Friday, 16 September 2022

## **Integrated Water Cycle Management Review of the Yiribana Logistics Estate in the Mamre Road Precinct**

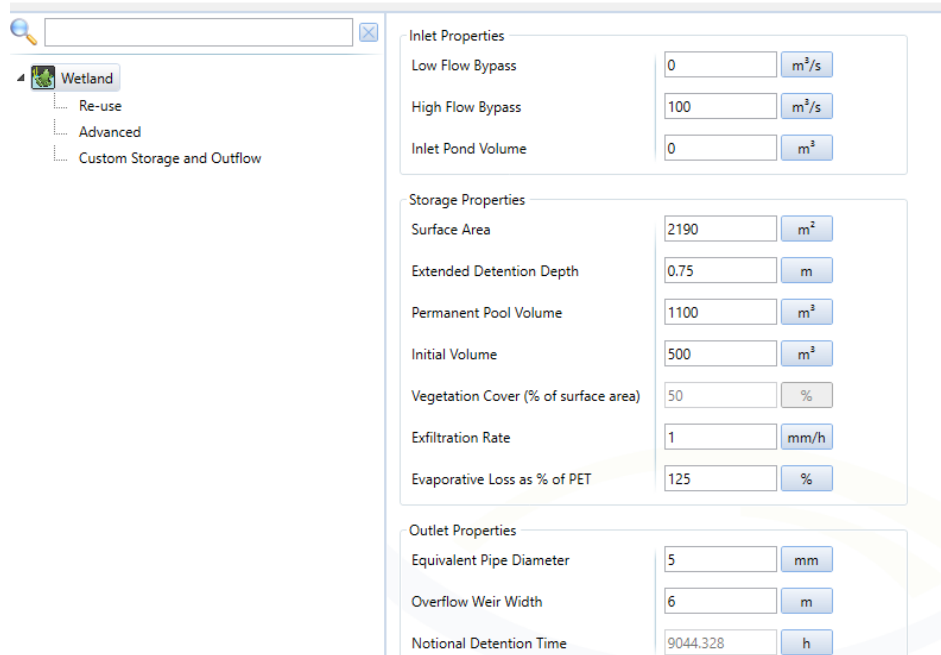
The irrigation re-use for this node is distributed as PET, rather than PET-Rain. This should be updated and resubmitted in a revised model, along with a detailed breakdown of the 6,250kL/year of re-use with a landscape plan clearly showing the areas proposed for irrigation.

The irrigation re-use distribution used in the model has been revised to PET-Rain.

A total area of 16,500m<sup>2</sup> has been proposed for irrigation (via Basin 2) that relates to a demand of 6,600 kL/year. However, a clear breakdown of the re-use demand has not been provided, please provide additional details including WSUD Summary Plan that clearly shows MUSIC modelling catchment boundaries, pervious/impervious areas, areas proposed for landscaped irrigation, location of all WSUD devices, etc. In addition, summary calculations for internal re-use figures should also be provided.

RIPARIAN STORAGE Editor

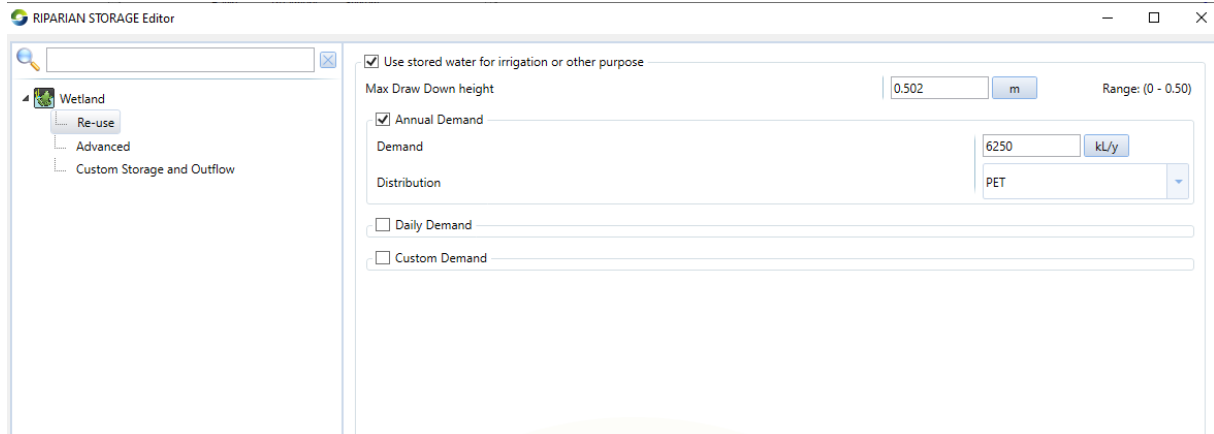
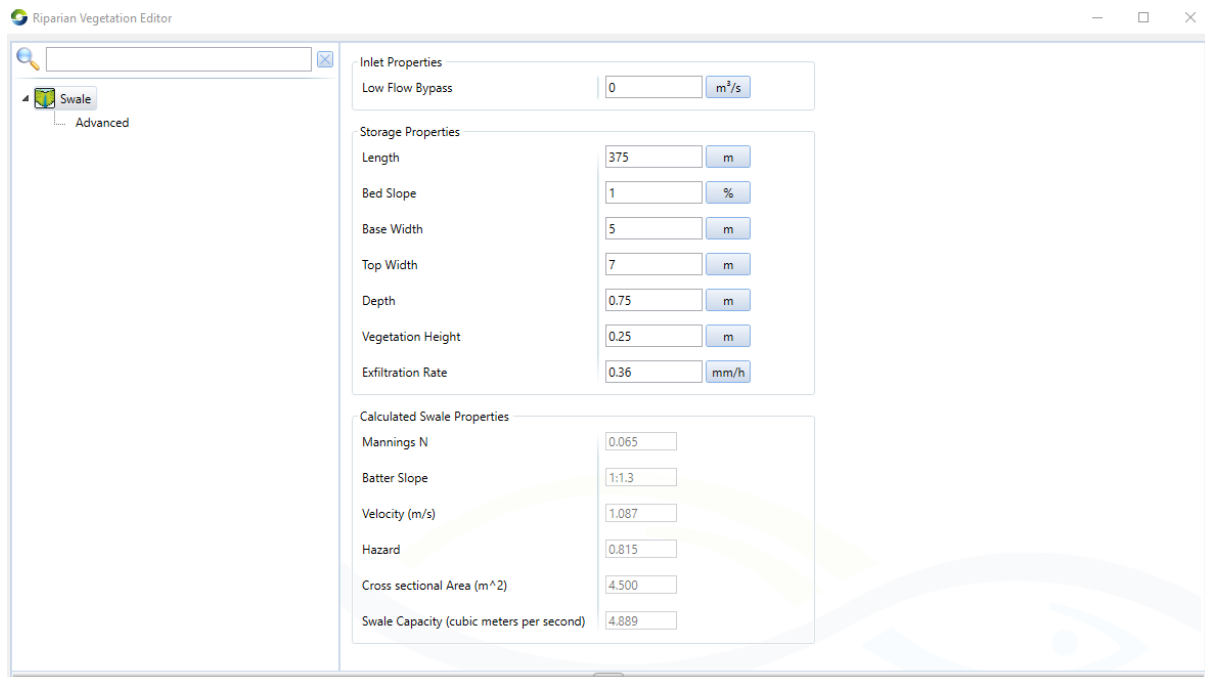
The initial Volume of the Basin is set to 500m<sup>3</sup> which is less than the permanent pool volume of 1,100m<sup>3</sup>. The initial volume should be equal to the permanent pool.

The 'Riparian Storage' node has been modified, now represented as a swale instead of a wetland.

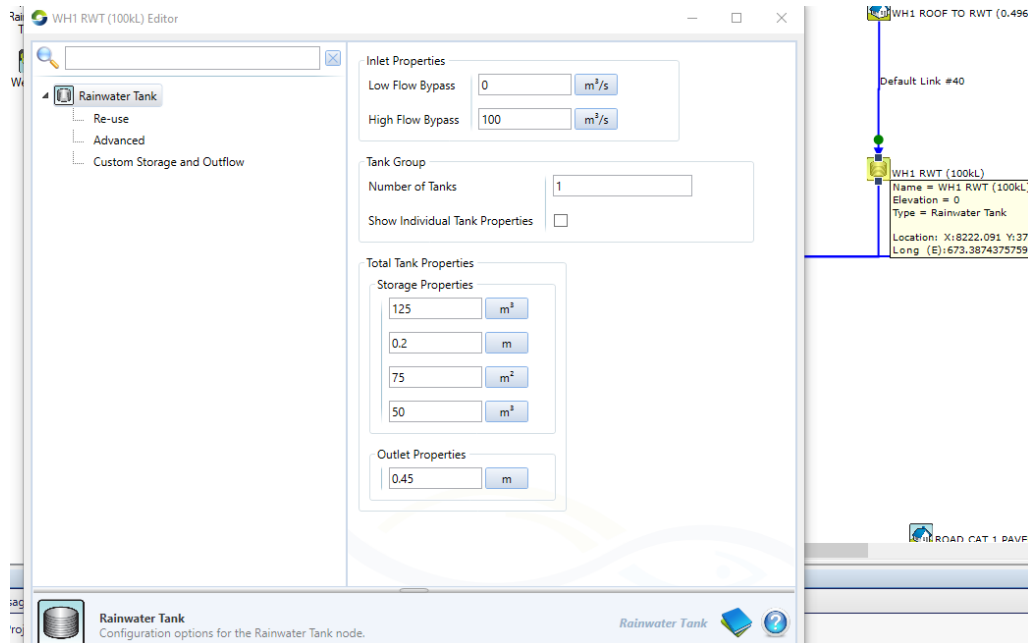
The proponent should confirm the rainwater tank volumes in MUSIC vs what is proposed on plan (e.g. WH1 RWT is noted as 100kL but the volume is modelled as 125kL). The modelled volume should be 80% of the physical rainwater tank volume, therefore if the notation of 100kL tank is correct, then the modelled volume should be 80kL.

Additionally, the size of rainwater tank in the Civil Engineering Plans appears to be relatively small in plan area. The tank dimensions should be confirmed as part of a response to this review.

We acknowledge the following response received from the proponent *“The modelled volume of rainwater tanks is based on 80% of that nominated on plan. The size of the rainwater tank on plan is nominal only. The final dimensions of the tank will be confirmed as part of detail design, or post approval, stage.”*

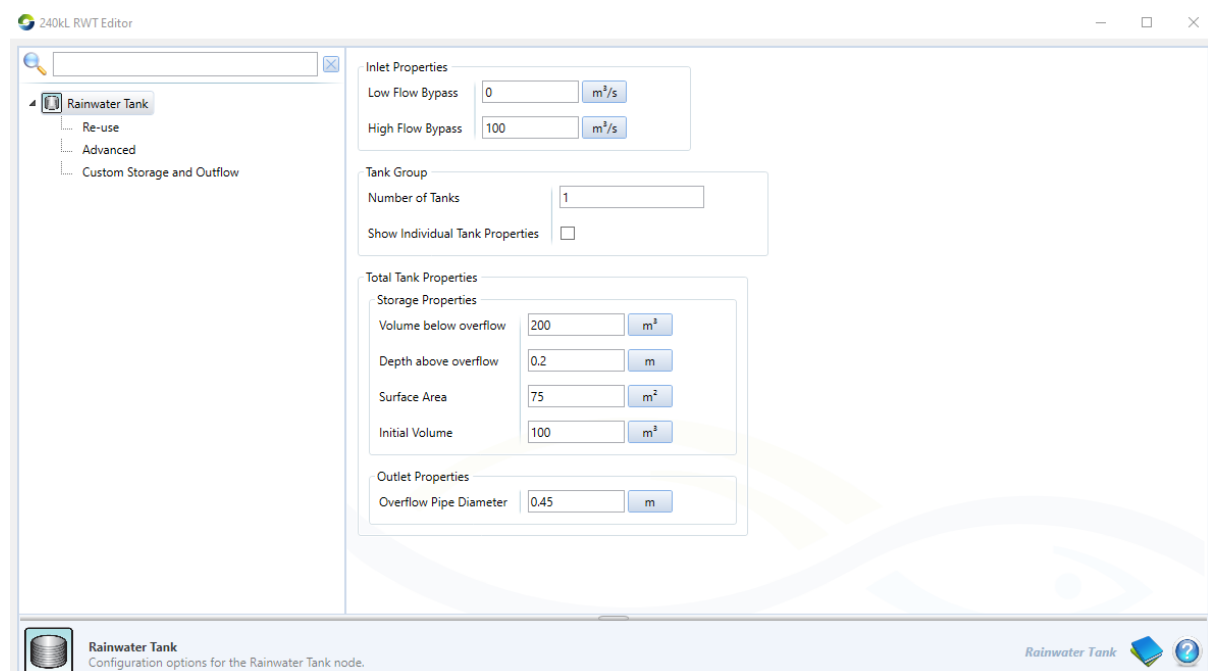
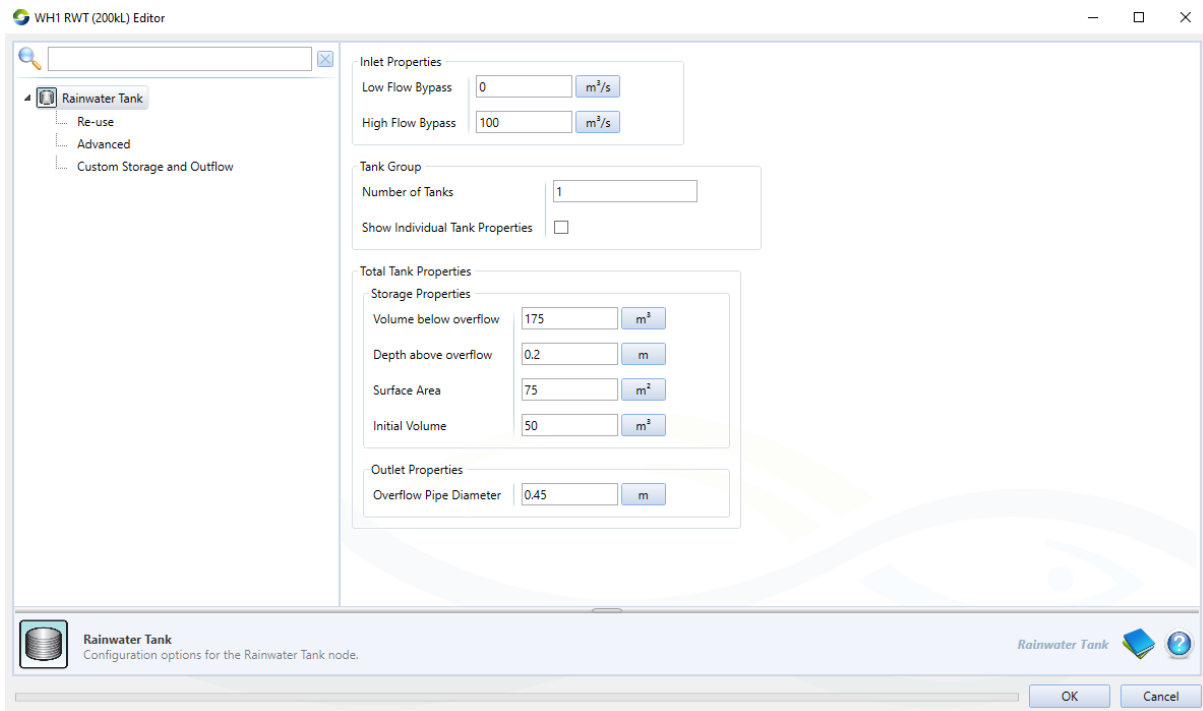
Details for rainwater tank properties are required to be confirmed to ensure the design satisfies water quality target objectives. This must include accurate high-flow bypass rates, noting that the proponent has 100m<sup>3</sup>/s for all tanks which is impossible and inflates results (as outlined above).

## Street Tree Irrigation

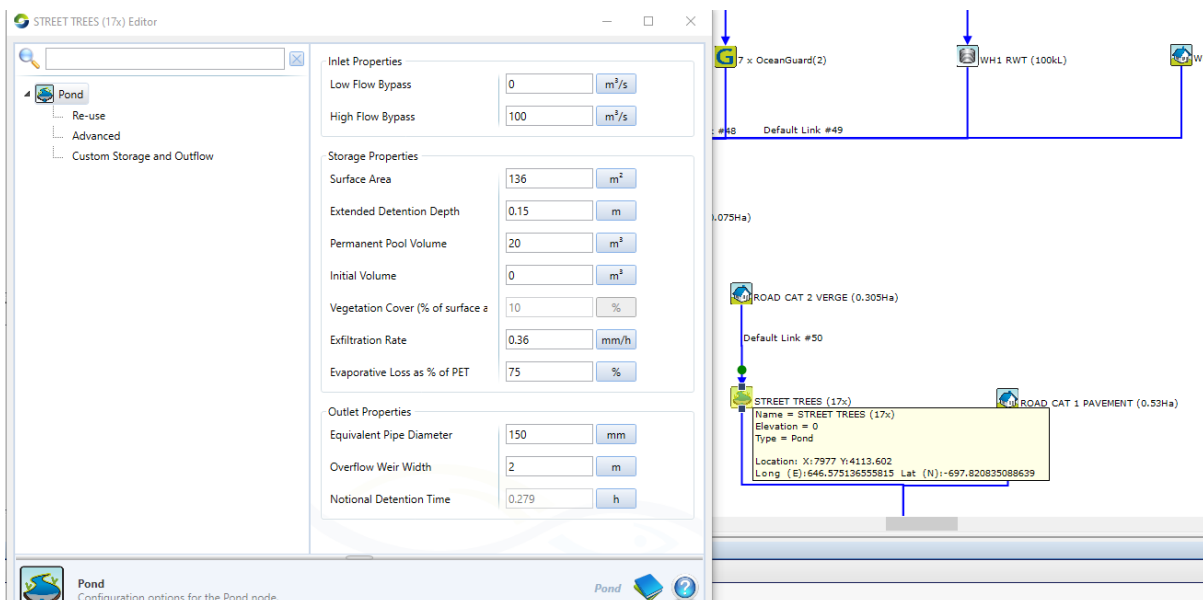
The proponent should confirm the high flow bypass rate of the street trees and bioretention (currently modelled as  $100\text{m}^3/\text{s}$ ). Based on area and extended detention depth we would expect bypass to be closer to 3-month ARI.

We note that the high flow by-pass has been updated to  $0.75\text{m}^3/\text{s}$  to suit the 3-month ARI design flow rate.
